Economic Commission for Europe**Inland Transport Committee****World Forum for Harmonization of Vehicle Regulations****Working Party on Passive Safety****Fifty-ninth session**

Regulation No. 129 (Enhanced Child Restraint Systems)**Proposal for the 02 series of amendments to Phase 2 of
Regulation No. 129 (Enhanced Child Restraint Systems)****Submitted by the expert from France***

Annex 2, amend to read:

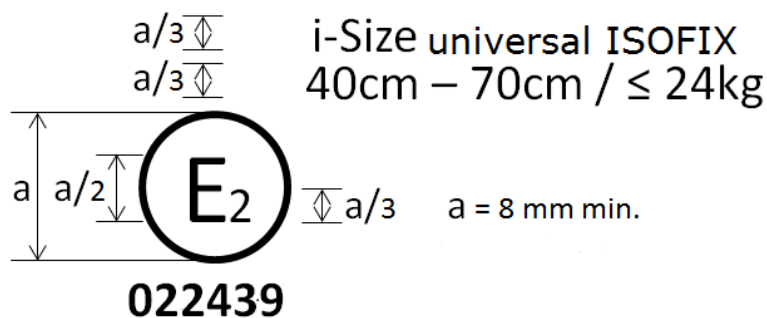
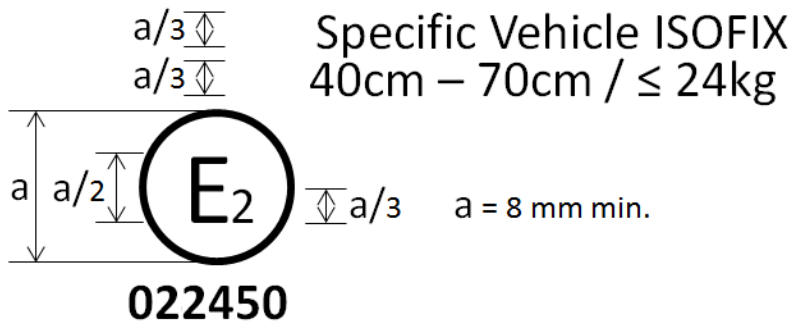
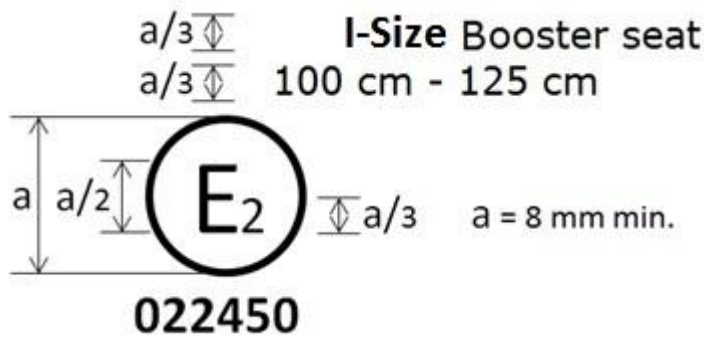
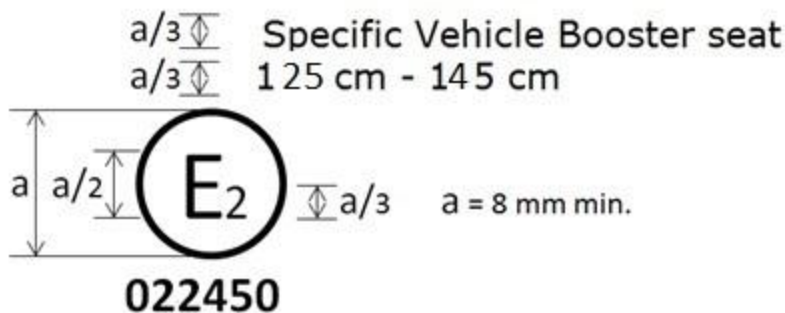
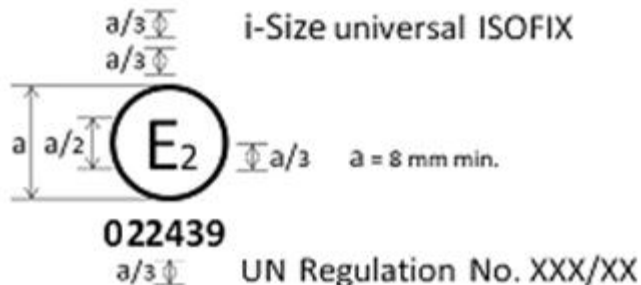
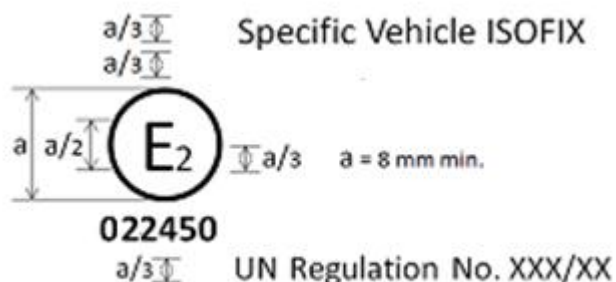
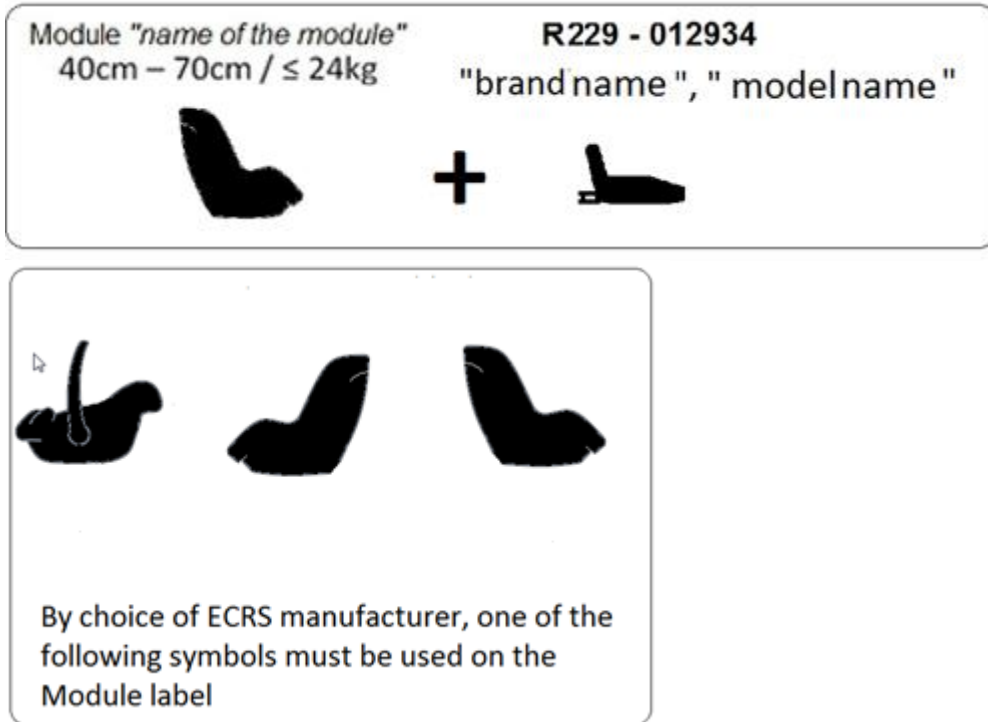
The Enhanced Child Restraint System bearing the above approval mark is a device capable of being fitted in any i-size compatible vehicle seating position and of being used for the 40 cm - 70 cm size range and mass limit of 24 kg; it is approved in France (E 2) under the number 022439. The approval number indicates that the approval was granted in accordance with the requirements of the Regulation concerning the approval of Enhanced Child Restraint Systems used onboard of motor vehicles as amended by the 02 series of amendments. In addition the name of the regulation has to be identified on the approval mark followed by the series of amendment according to which the approval has been granted.

The Enhanced Child Restraint System bearing the above approval mark can be fitted in any i-Size booster seating position and used for the 100 cm - 125 cm size range; it is approved in France (E 2) under the number 022439. The approval number indicates that the approval was granted in accordance with the requirements of the Regulation concerning the approval of Enhanced Child Restraint Systems used on-board of motor vehicles as amended by the 02 series of amendments. In addition, the name of the regulation is to be identified on the approval mark followed by the series of amendment according to which the approval has been granted.

The Enhanced Child Restraint System bearing the above approval mark is a device not capable of being fitted in every vehicle but capable of being used for the 125 cm - 145 cm size range; it is approved in France (E 2) under the number 022450. The approval number indicates that the approval was granted in accordance with the requirements of the Regulation concerning the approval of specific vehicle booster seat Enhanced Child Restraint Systems used onboard of motor vehicles as amended by the 02 series of amendments. In addition the name of the regulation has to be identified on the approval mark followed by the series of amendment according to which the approval has been granted.

In case the ECRS is equipped with a module, the size range is not on the approval mark but on the module mark.

"Annex 6 - Appendix 2

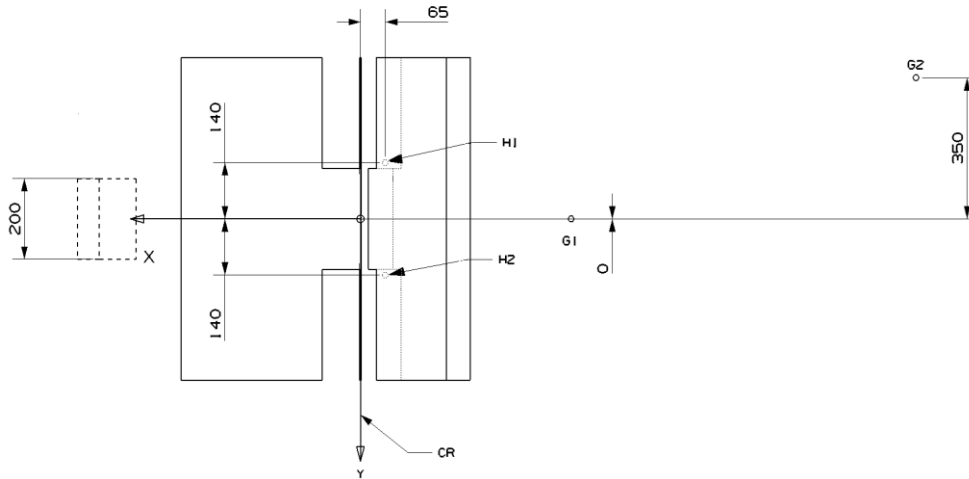
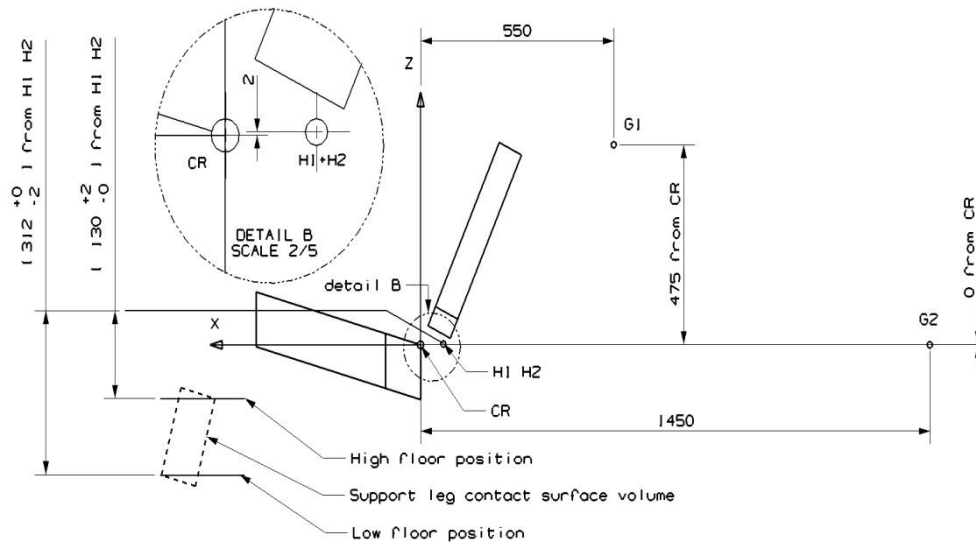
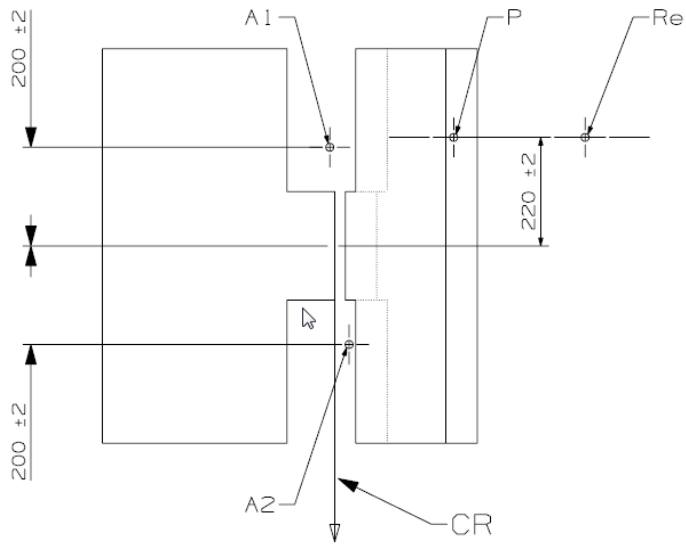
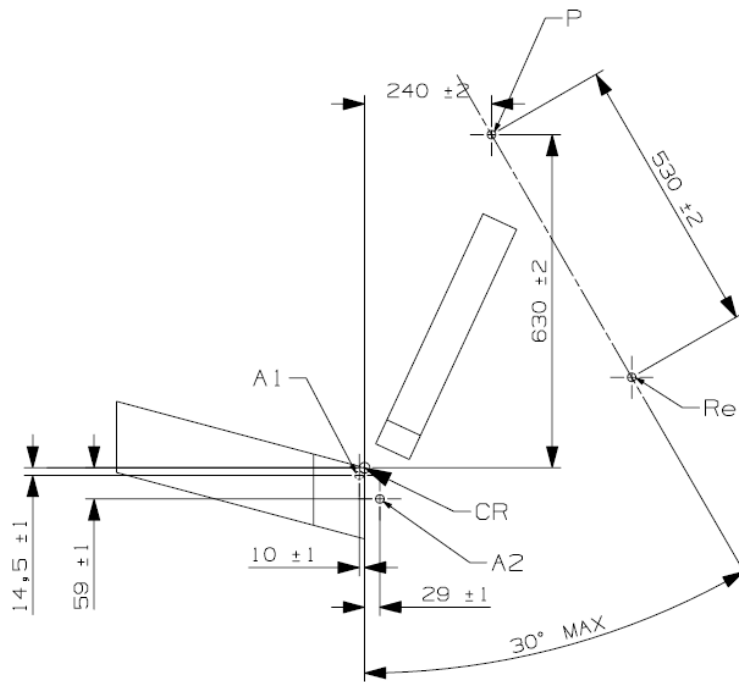
1. The anchorages shall be positioned as shown in the figure below.
2. Enhanced Child Restraint Systems in the i-Size universal, specific and restricted categories shall use the following anchorage points: H₁ and H₂.
3. For testing of Enhanced Child Restraint Systems with top tether, the anchorage G₁ or G₂ shall be used.
4. In the case of Enhanced Child Restraint Systems utilising a support-leg, the Technical Service shall select the anchorages to be used according to

The following table gives the belt anchorages points.

Distance (mm)	-240	-220	-630	-29	200	59	10	-200	14.5
------------------	------	------	------	-----	-----	----	----	------	------

Geometrical dimensions of Enhanced Child Restraint Systems

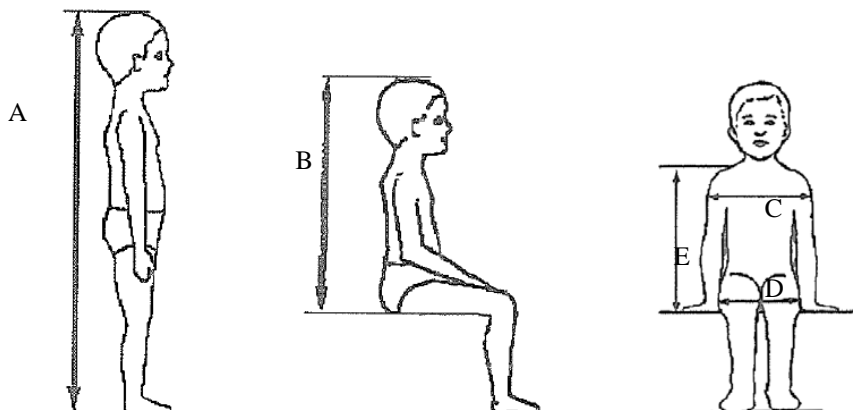
<i>Stature cm</i>	<i>Minimum Sitting height cm</i>	<i>Minimum Shoulder breadth cm</i>	<i>Minimum Hip breadth cm</i>	<i>Minimum Shoulder height cm</i>	<i>Maximum Shoulder height cm</i>
<i>A</i>	<i>B</i>	<i>C</i>	<i>D</i>	<i>E1</i>	<i>E2</i>
	<i>95%ile</i>	<i>95%ile</i>	<i>95%ile</i>	<i>5%ile</i>	<i>95%ile</i>
<40				<27.4	
45	39.0	12.1	14.2	27.4	29.0
50	40.5	14.1	14.8	27.6	29.2
55	42.0	16.1	15.4	27.8	29.4
60	43.5	18.1	16.0	28.0	29.6
65	45.0	20.1	17.2	28.2	29.8
70	47.1	22.1	18.4	28.3	30.0
75	49.2	24.1	19.6	28.4	31.3
80	51.3	26.1	20.8	29.2	32.6
85	53.4	26.9	22.0	30.0	33.9
90	55.5	27.7	22.5	30.8	35.2
95	57.6	28.5	23.0	31.6	36.5
100	59.7	29.3	23.5	32.4	37.8
105	61.8	30.1	24.9	33.2	39.1
110	63.9	30.9	26.3	34.0	40.4
115	66.0	32.1	27.7	35.5	41.7
120	68.1	33.3	29.1	37.0	43.0
125	70.2	34.5 33.3	30.5 29.1	38.5	44.3
130	72.3	35.7 33.3	31.9 29.1	40.0	46.1
135	74.4	36.9 33.3	33.3 29.1	41.5	47.9
140	76.5	38.1 34.2	34.7 29.6	43.0	49.7

145	78.6	39.3 35.3	36.3 30.8	44.5	51.5
150	81.1	41.5 36.4	37.9 32.0	46.3	53.3

Standard safety-belt

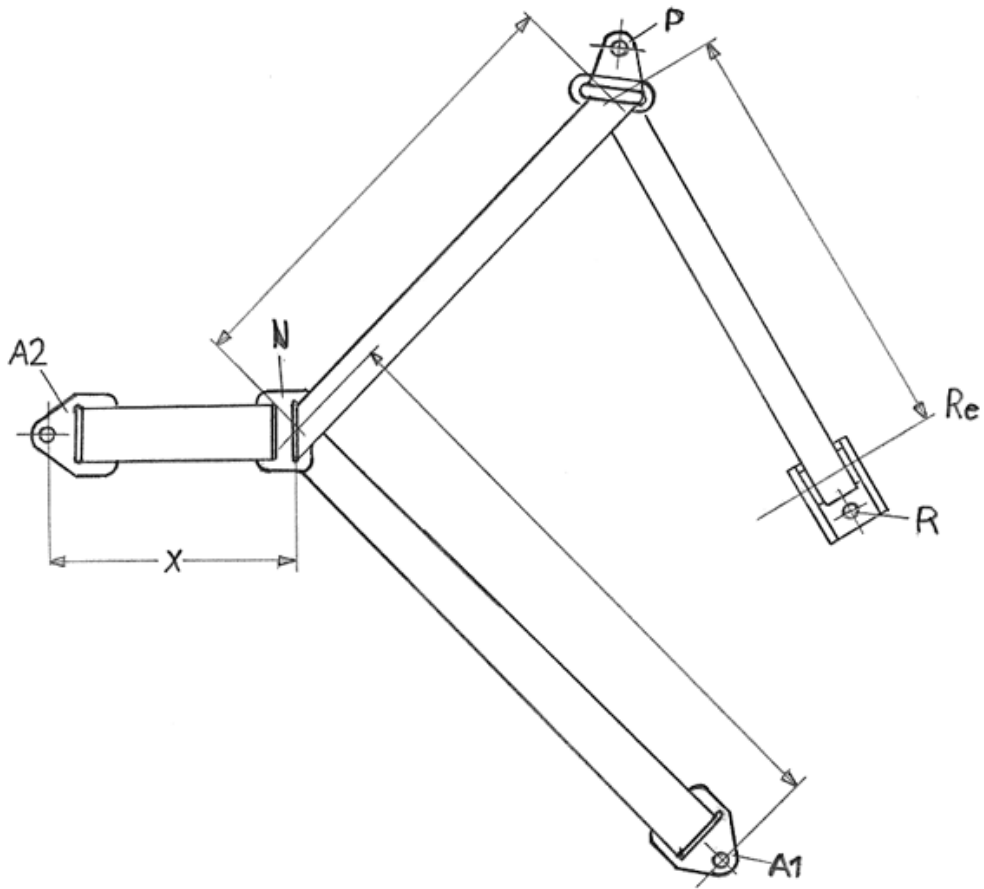
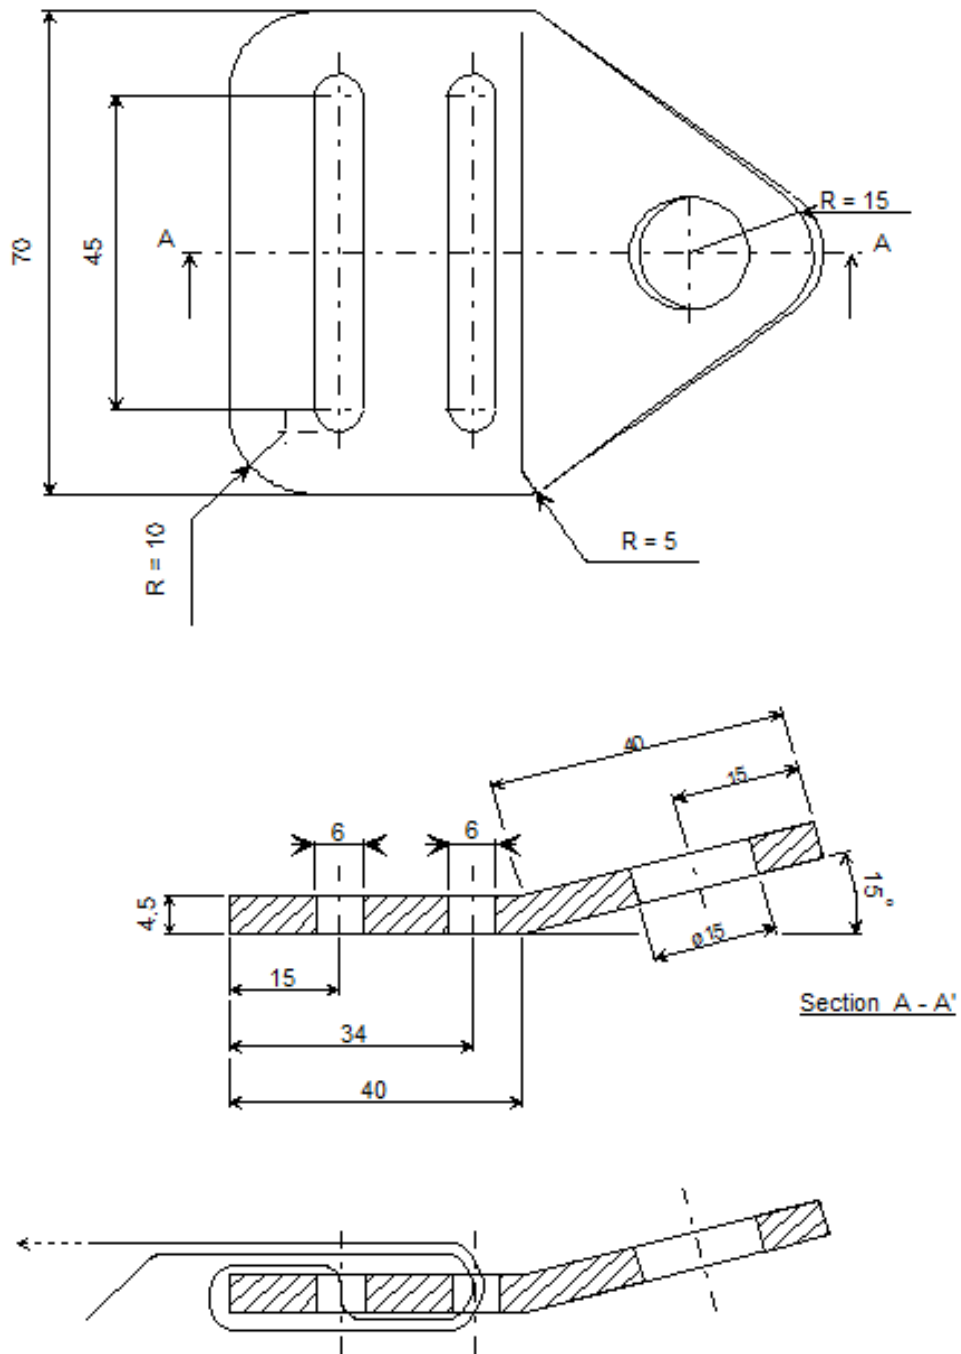
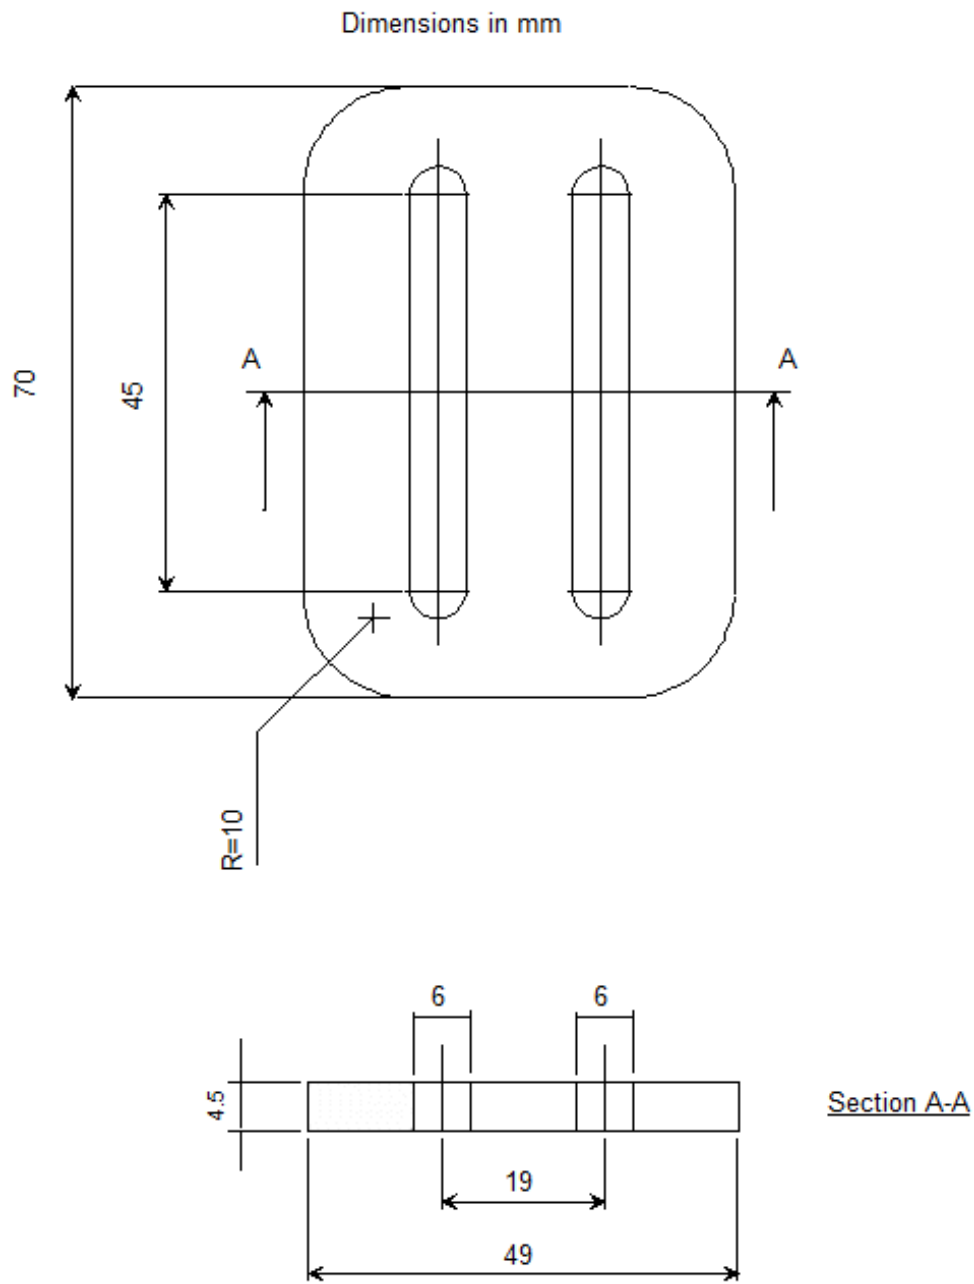
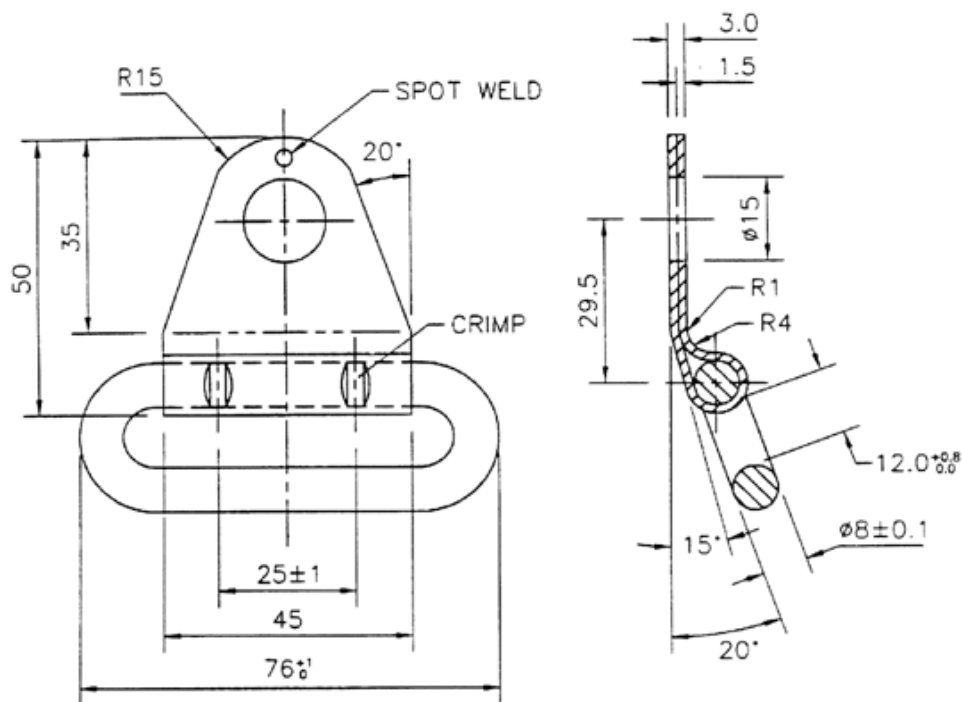
1. The safety-belt for the dynamic test and for the maximum length requirements shall be made according to the configuration shown in Figure 1. These are a three-point retracting belt system.

2. The three-point retracting belt has the following rigid parts: a retractor (R), a pillar loop (P), two anchorage points (A1 and A2) (see Figure 1), and a central part (N, in detail in Figure 3). The retractor shall comply with the requirements of Regulation No. 16 (paragraph 6.2.5.2.2.) for retraction force. The retractor spool diameter is 33 ± 0.5 mm [(example is given in Mutual Resolution No. 1 (M.R.1))].

3. The retracting belt shall be fitted to the anchorages on the test bench, described in Annex 6, Appendix 2 as follows:
 - (a) Belt anchorage A1 shall be fitted to trolley anchorages B0 (outboard);

- (b) Belt anchorage A2 shall be fitted to trolley anchorage A (inboard);
 - (c) Belt pillar loop P shall be fitted to trolley anchorage C;
 - (d) Belt retractor R shall be fitted to trolley anchorage such that the spool centre line is positioned on Re.

The value of X in Figure 1 below is 200 ± 5 mm. The effective strap length between A1 and the centre line of the retractor spool Re (when the webbing is fully extracted including the minimum length of 150 mm for testing of Enhanced Child Restraint System shall be $[2820] \pm 5$ mm when measured in a straight line without load and on a horizontal surface. This length may be increased for the testing of restricted categories; for all categories with the Enhanced Child Restraint System installed, there shall be a minimum of 150 mm of strap length on the retractor spool.

4. The strap requirements for the belt as follows:
 - (a) Material: polyester spinnblack;
 - (b) Width: 48 ± 2 mm at 10,000 N;
 - (c) Thickness: 1.0 ± 0.2 mm;
 - (d) Elongation: 8 ± 2 per cent at 10,000 N.
